ULNRC- 04258

DOCKET NUMBER 50-483
UNION ELECTRIC COMPANY
CALLAWAY PLANT

REVISION TO TECHNICAL SPECIFICATIONS 3.3.2, 3.4.10, AND 3.4.11
PRESSURIZER SAFETY VALVES AND PORVS

CALLAWAY PLANT
FIGURE 15.5-1 INADVERTENT OPERATION OF ECCS DURING POWER OPERATION

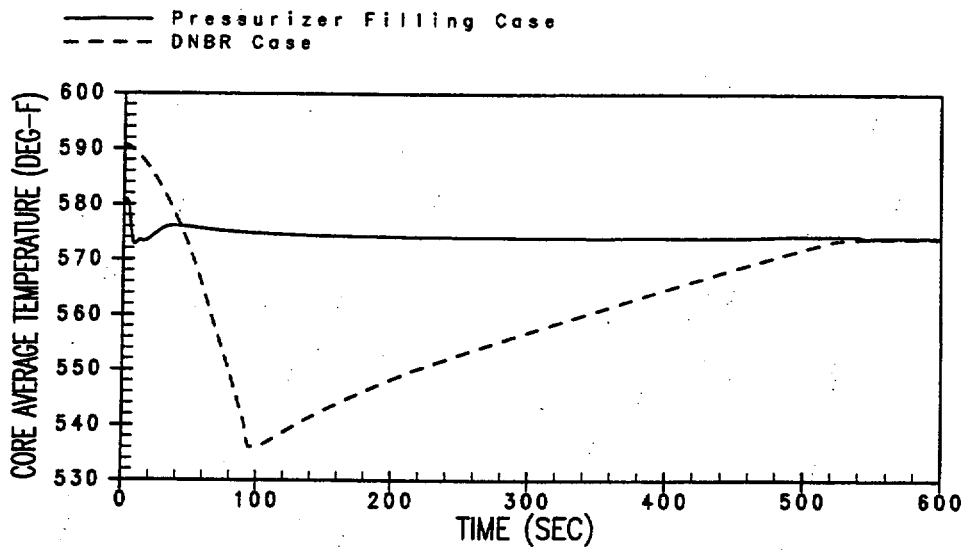
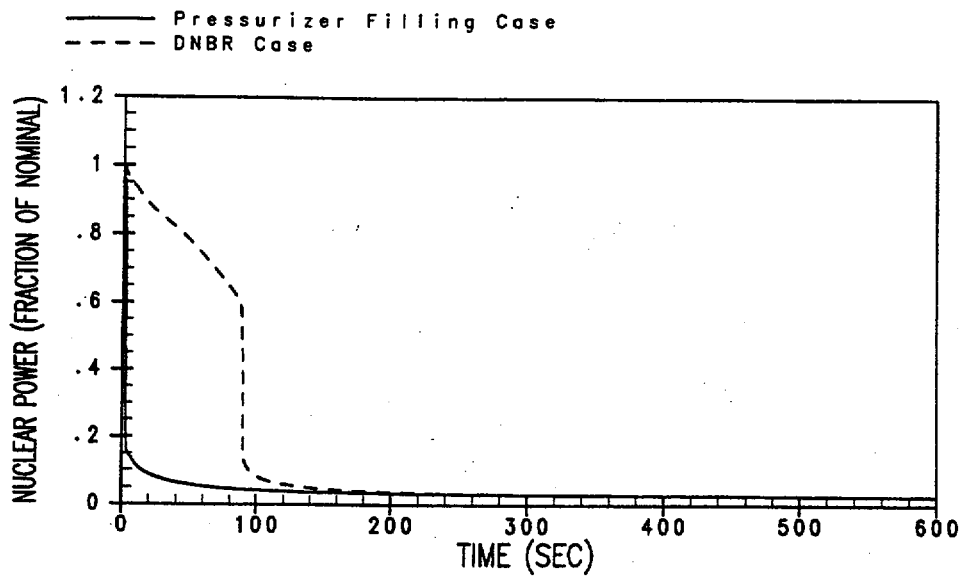
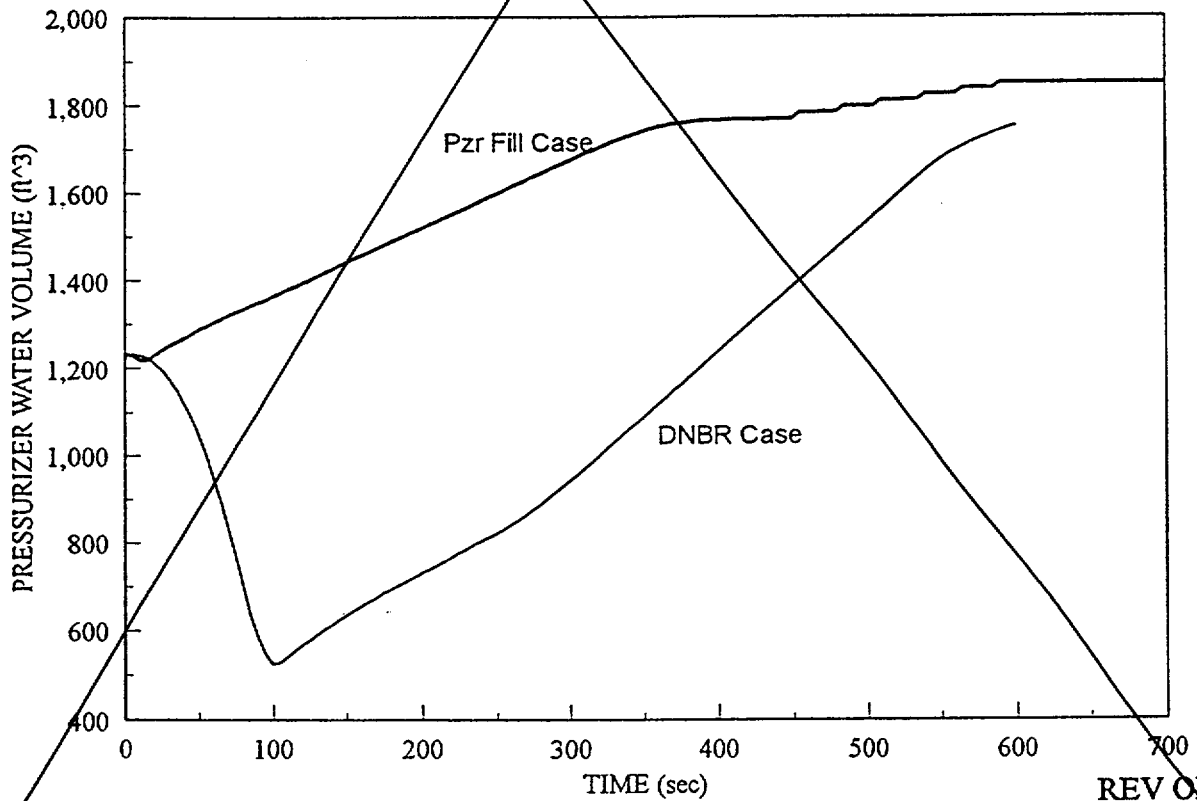
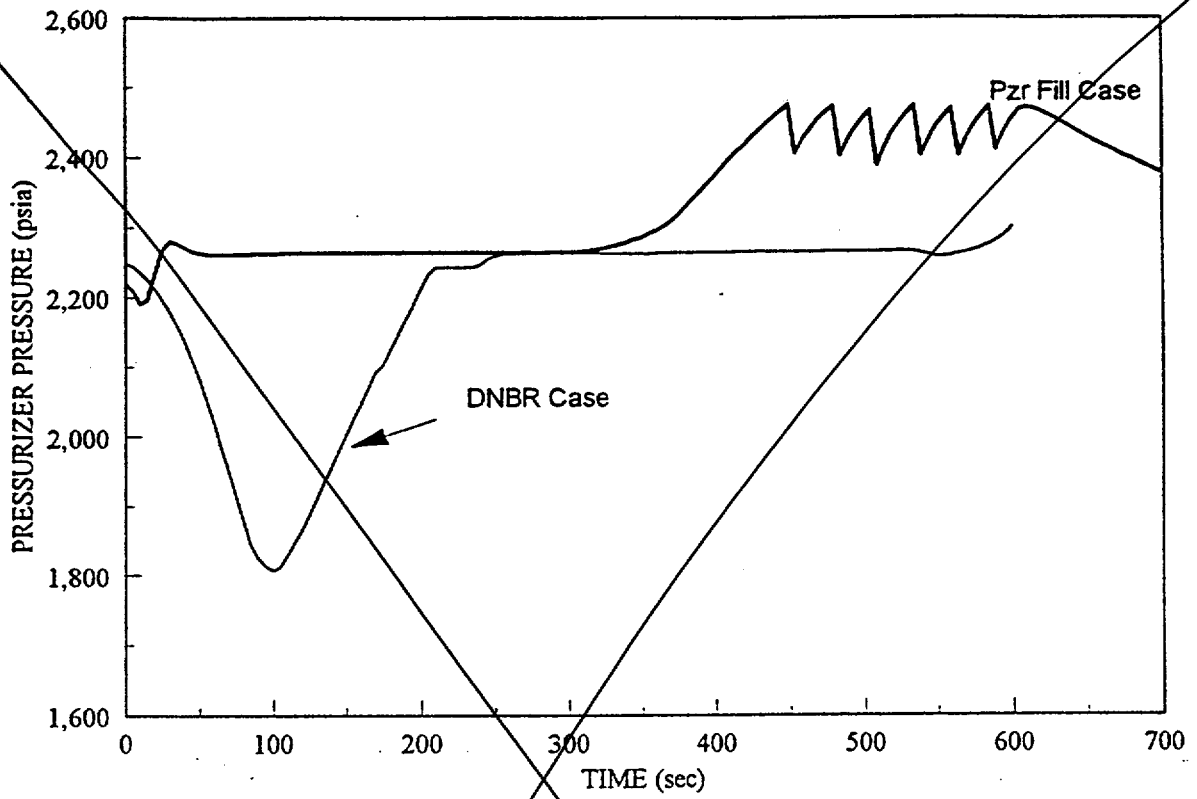
(Replace with following page)

FIGURE 15.5-2
INADVERTENT OPERATION OF ECCS
DURING POWER OPERATION

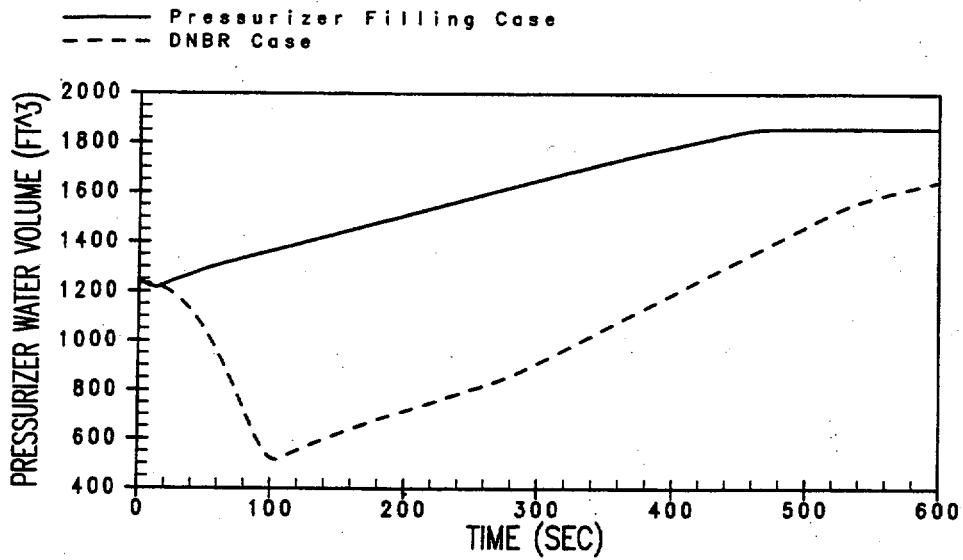
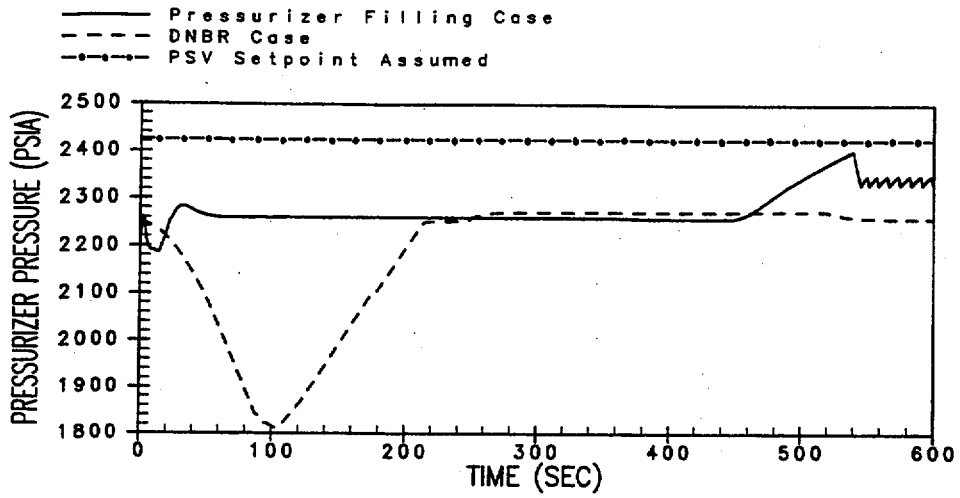
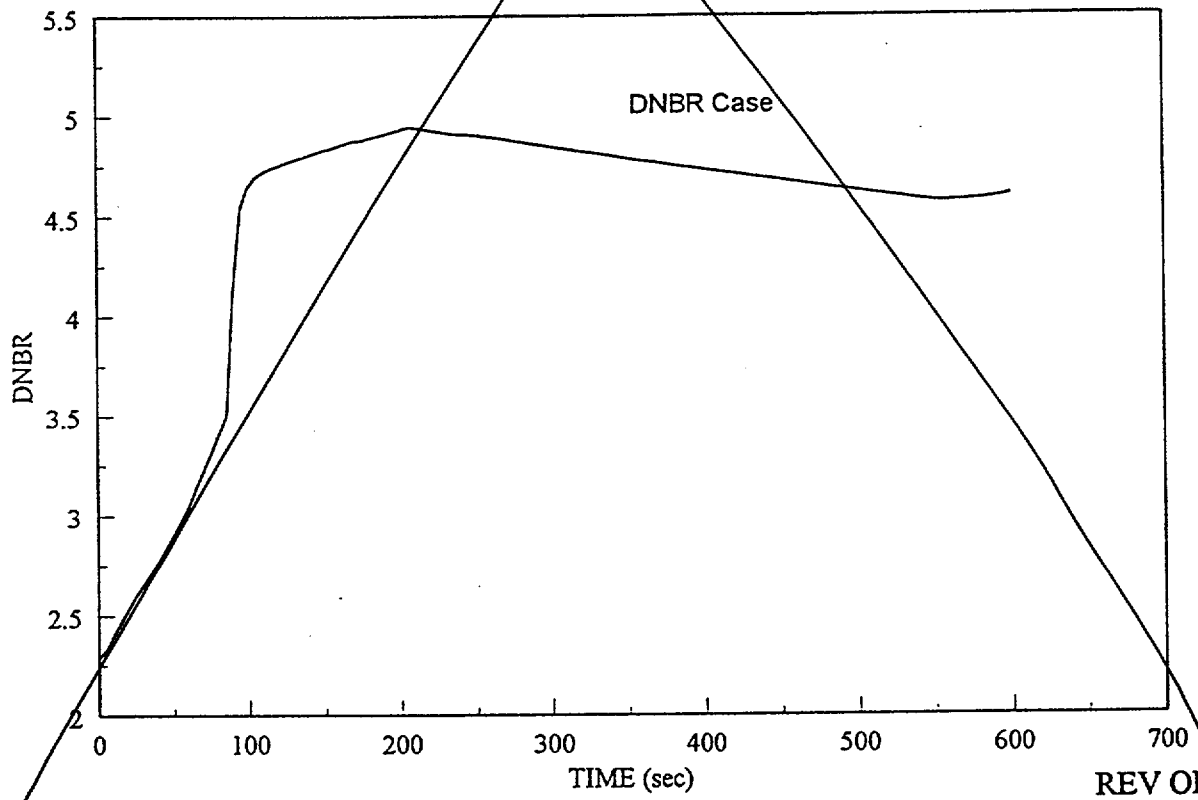
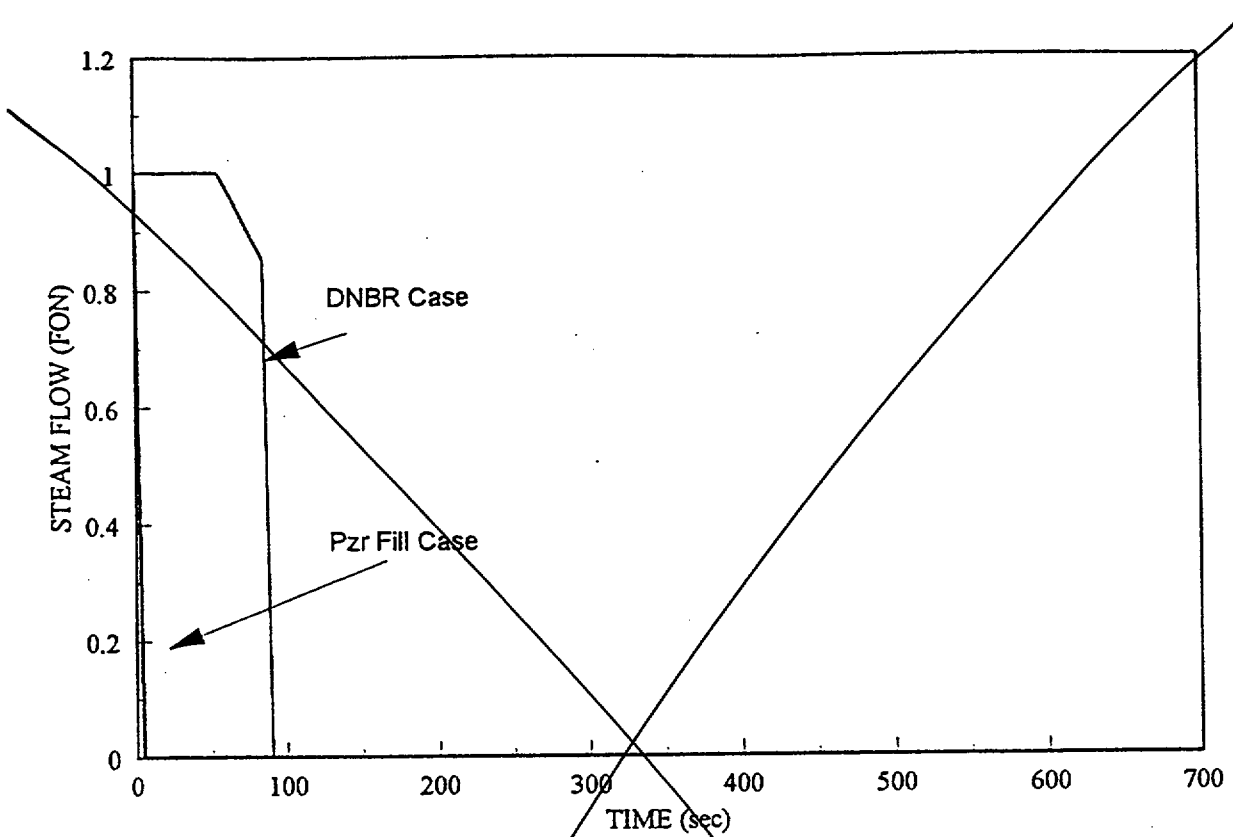
(Replace with following page)

CALLAWAY PLANT
FIGURE 15.5-3 INADVERTENT OPERATION OF ECCS DURING POWER OPERATION

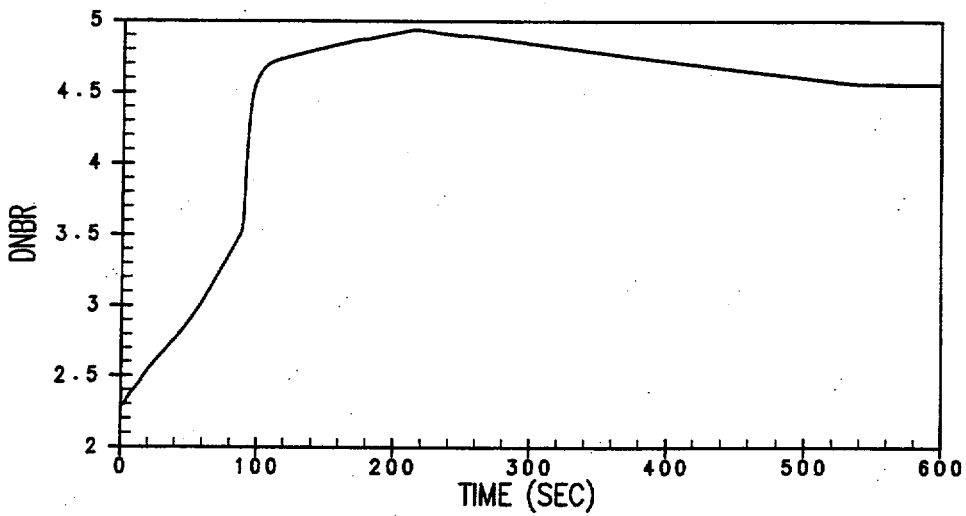
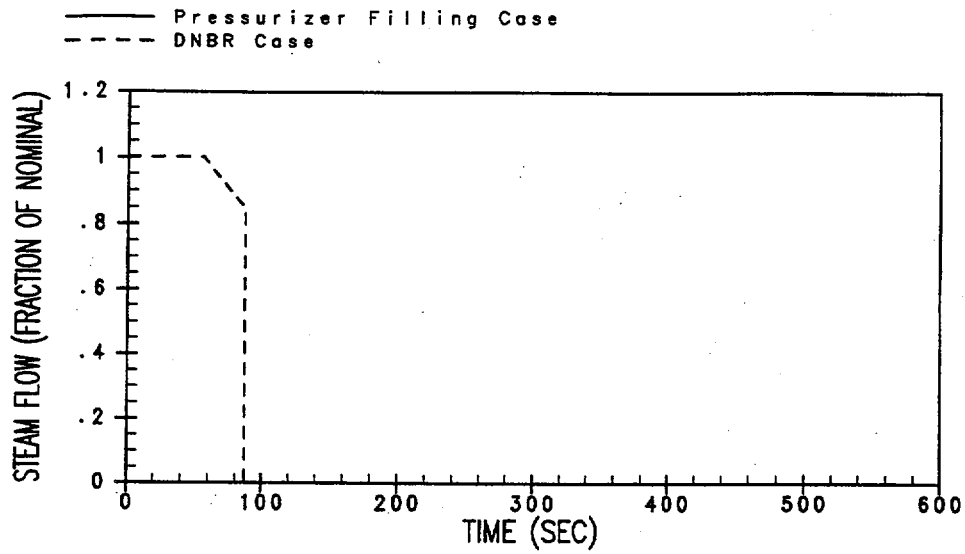
(Replace with following page)

FIGURE 7.2-1
FUNCTIONAL DIAGRAMS
(PRESSURIZER PRESSURE AND
LEVEL CONTROL)

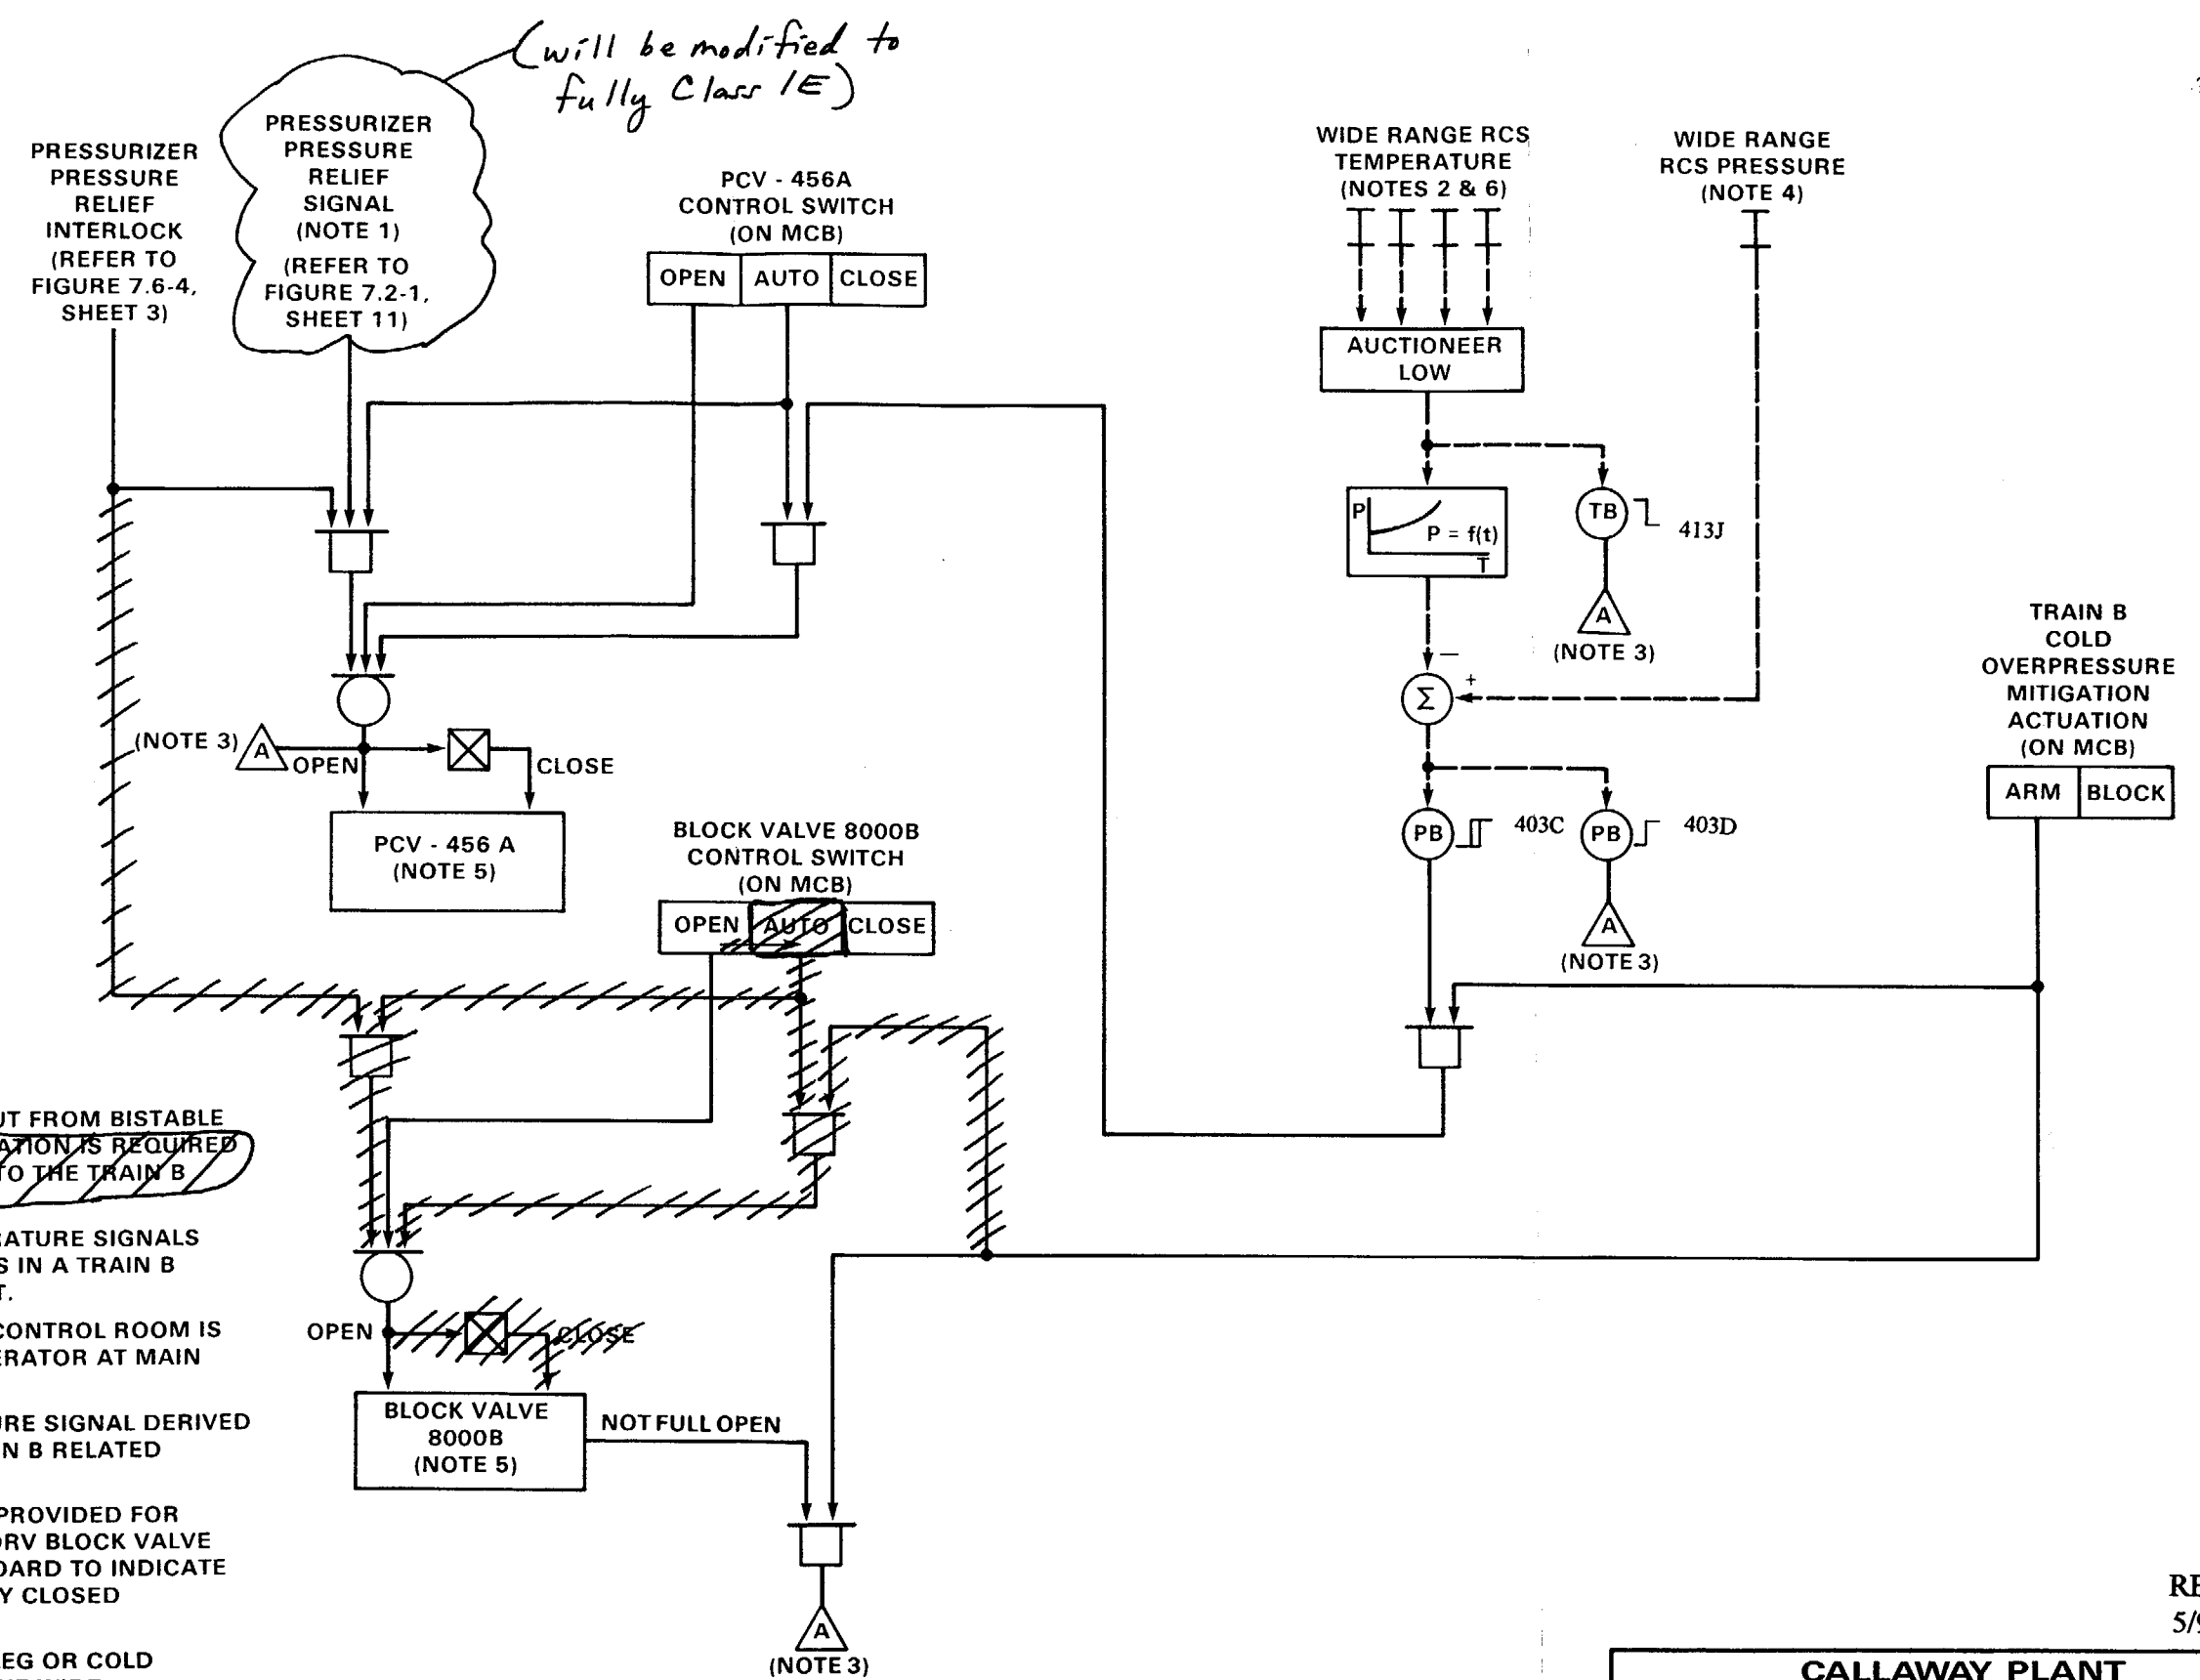
separation groups 5 and 6 (see FSAR Figure 7.2-1 sheet 11 in Attachment 6). Since the accident analyses do not rely on the automatic actuation of non-safety related control grade systems or components for accident mitigation, a modification will be implemented during the next refueling outage to upgrade the automatic pressurizer PORV pressure relief circuitry to fully Class 1E.

In the current design, the PORV opening logic is control grade circuitry that actuates on a one out of one (1/1) logic (see FSAR Figure 7.2-1 sheet 11 in

Attachment 6). A selectable control switch is provided so that either one of two channels can be selected to control each PORV. The current PORV closure logic is safety grade based on a two out of four (2/4) pressurizer pressure low logic (see FSAR Figure 7.6-4 sheets 1-3 in Attachment 6). For the modification to upgrade the automatic actuation circuitry to fully Class 1E, the safety grade closure logic will be used in the design of the new safety grade opening logic. The new 2/4 opening actuation logic will be used to open the PORVs at a pressurizer pressure greater than 2350 psia (the same opening pressure as currently set). The new PORV closure actuation logic will be three out of four (3/4) that actuates when the pressurizer pressure drops 20 psi below the opening setpoint. The PORV opening circuitry will require energization to open the PORV. This design will minimize the potential for spurious opening of the PORVs. However, with the new actuation logic, two failed high channels of pressurizer pressure will result in an inadvertent opening of both PORVs and the PORVs would remain open until remote-manually closed. With the current control logic, while a single channel failing high would open one PORV, the closure logic would close that PORV when pressurizer pressure dropped below approximately 2200 psia. It would take three channels failed high for the PORVs to open and remain open in the current design.

Since the FSAR accident analyses do not rely on the automatic actuation of non-safety related control systems or components for accident mitigation, a plant modification will upgrade the automatic PORV actuation circuitry depicted in Attachment 6 to fully Class 1E.
